White Rock Wind Farm

Modification Application No.4

Proponents Response to Submissions

Document No. WR-PM-REP-0019

Figure 3.1 – Schematic Traffic Flows for WRWF Alternative Grid Construction Project

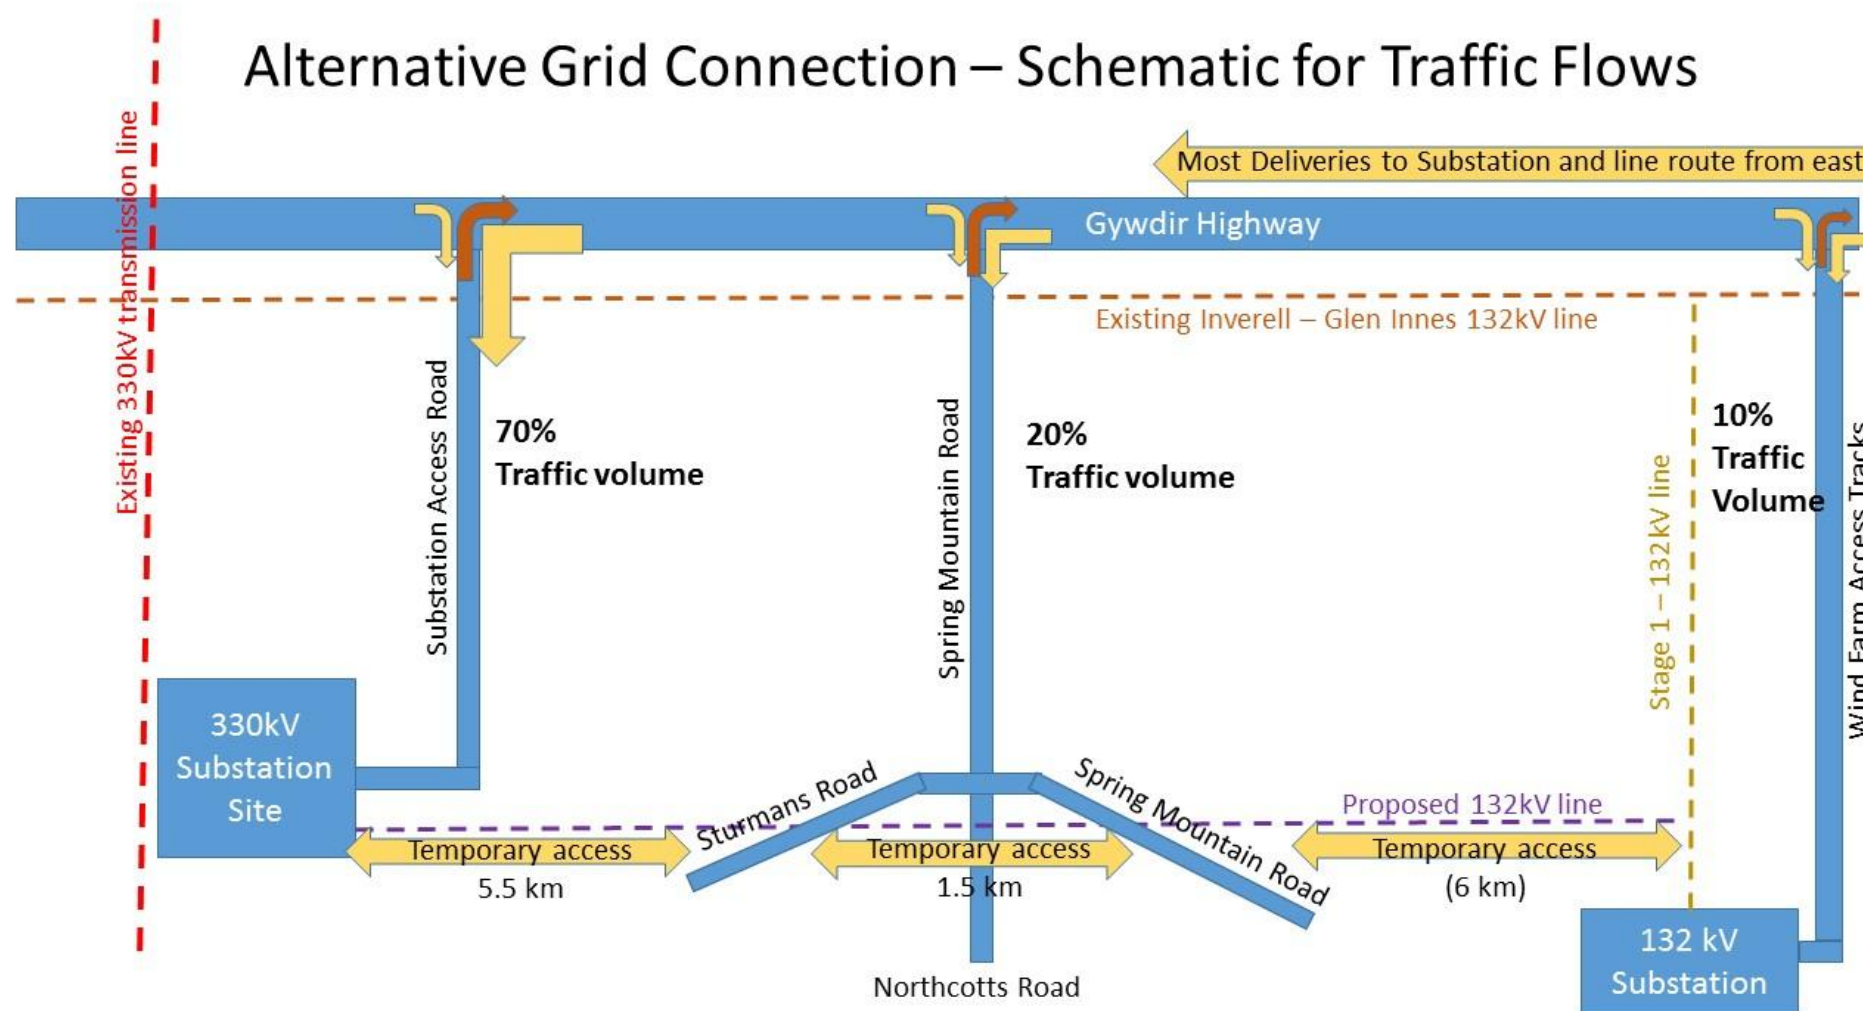
- The developer seek in-principle agreement from RMS to the concept designs for all works deemed necessary on the classified (State) road network (Gwydir Highway). This should be sought prior to the approval of the modification to enable the works to be included in the Conditions of Approval.

The distribution of construction traffic flows is anticipated to be predominantly via the western entrance involving access to the substation and western section of the 132kV line. Construction staff for the alternative grid connection works are most likely to utilize a temporary construction facility at the substation site. Lesser volumes of construction traffic flow will be to the middle and eastern site access routes. A schematic illustration of traffic flows is provided in Figure 3.1.

Figure 3.3 – Location of mineral titles relative to the proposed 132kV line

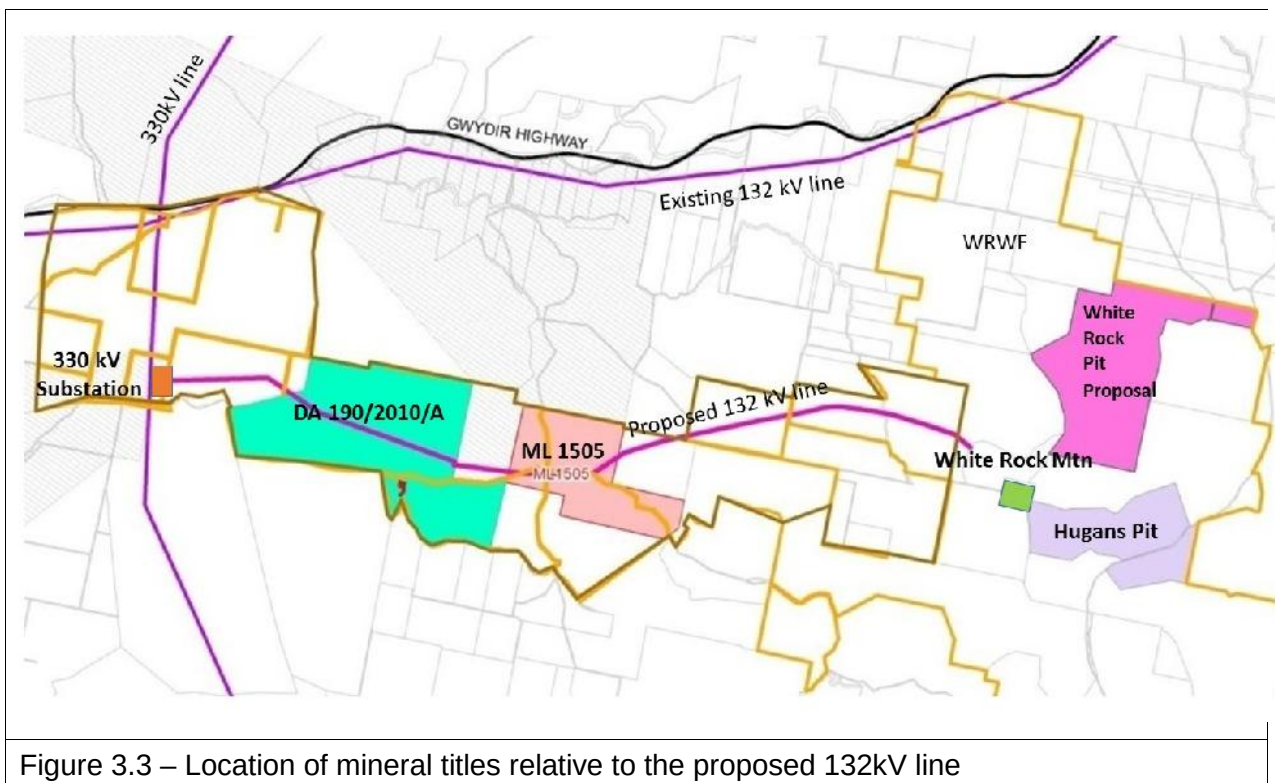
DRE requires that the Proponent continue consultation with the holder of ML1505 and provide DRE with a record of the consultation and any agreement reached.

WRWFPL is aware of these mineral resource ventures and notes that latter two (White Rock Pit Proposal and Hugans Pit) are to the east of White Rock Mountain and are not impacted by the MOD 4 proposal. In the case of the ventures on the Frazier property, these are in close proximity to the proposed 132kV transmission line.

For the MOD 4 project to proceed as outlined in the MOD 4 Application, WRWFPL needs the agreement of the landowner who is also the lease holder for ML 1505 and proponent for DA 190/2010/A. Previous correspondence was obtained, dated 10 October 2013 stating the landowner's consents to the transmission line passing through ML 1505 as shown in the figure accompanying the letter (Appendix C). An Option for an Easement to form a transmission line corridor across the subject property (Lots 141 and 142 / DP 753305) (including the areas of ML1505 and DA 190/2010/A) has also been entered into between WRWFPL and the landowner.

Figure 1- Quarry DA's and current titles within the White Rock Wind Farm Mod 4 area.

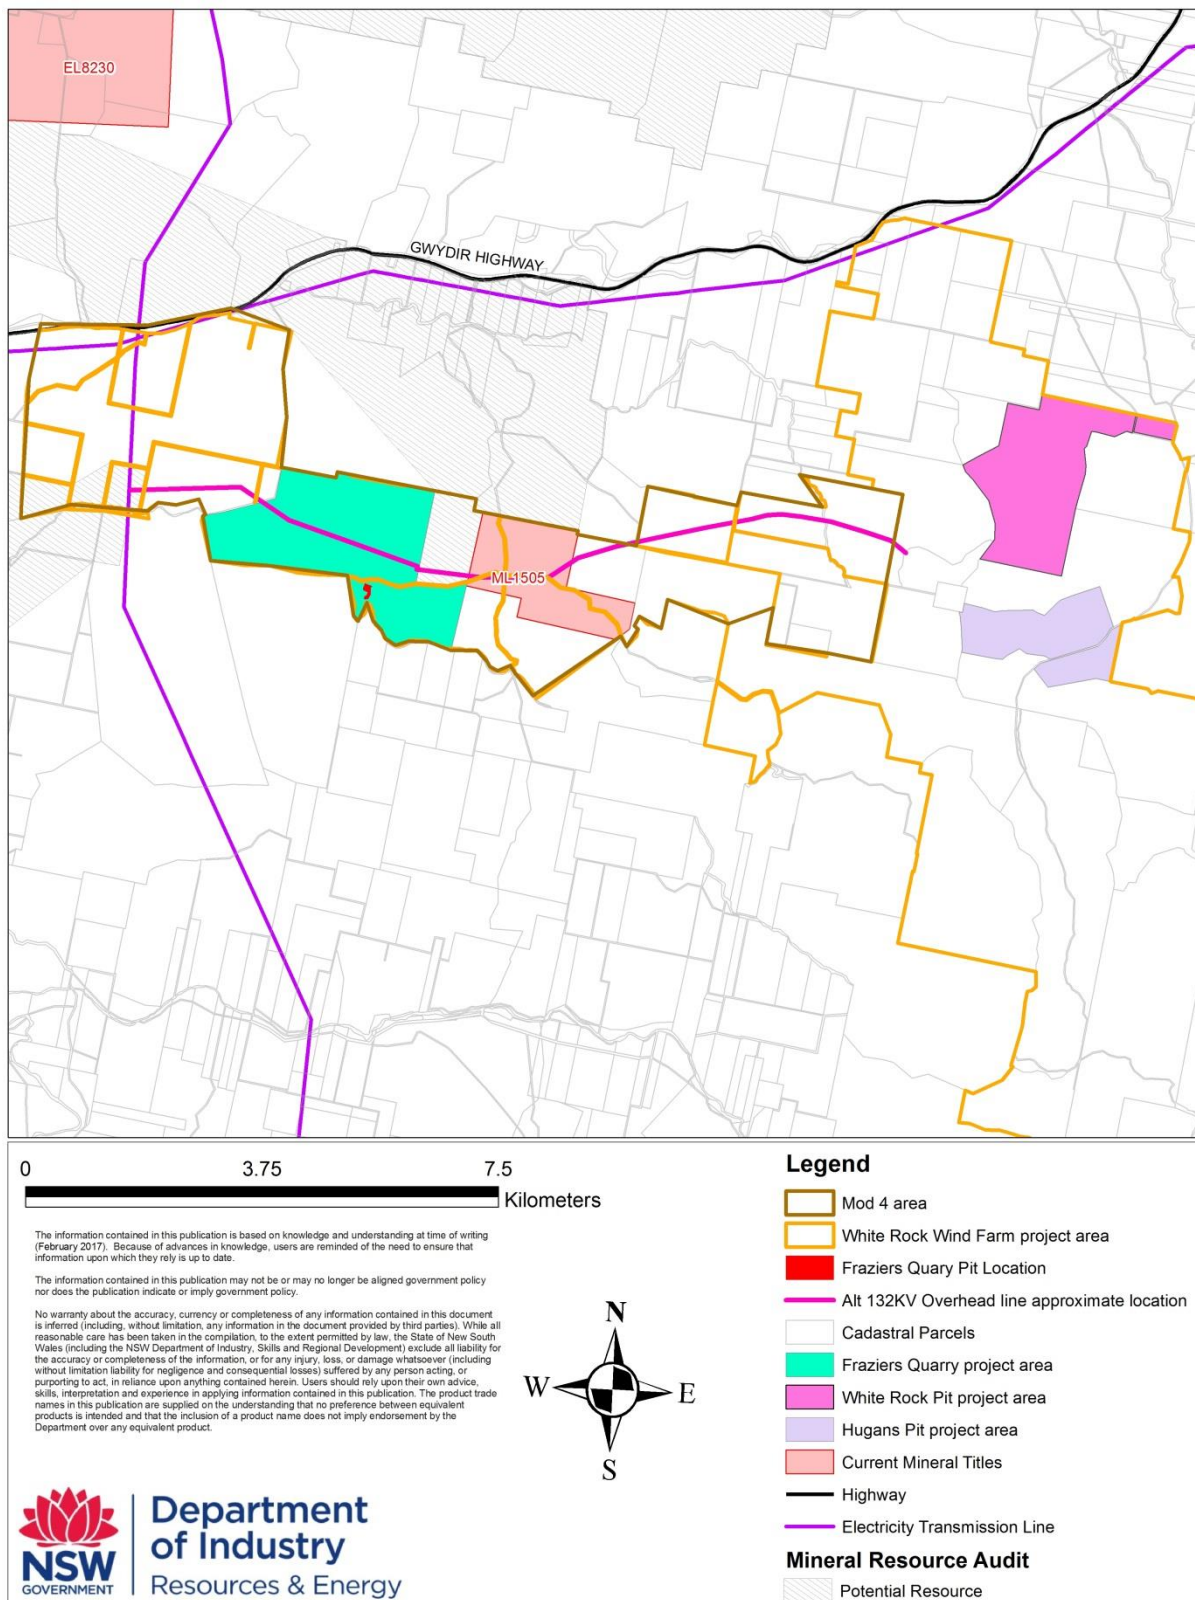
DRE is aware of three quarry development applications within the greater project area in 2016 (Refer to **Figure 1**).

- The Fraziers Quarry (distinct from the Fraziers Sapphire Mine - ML1505) modification (Inverell Council DA-190/2010/A - for increased extraction) is located within the Mod. 4 area.
- White Rock Pit Proposal - Glen Innes Severn Council DA58/16-16 - proposal to extract basalt at an annual extraction rate of 29500m³ from an estimated 250,000m³ resource.
- Hugans Pit - Glenn Innes Severn Council DA No. 52/15-16 - modification to an approved extractive industry.
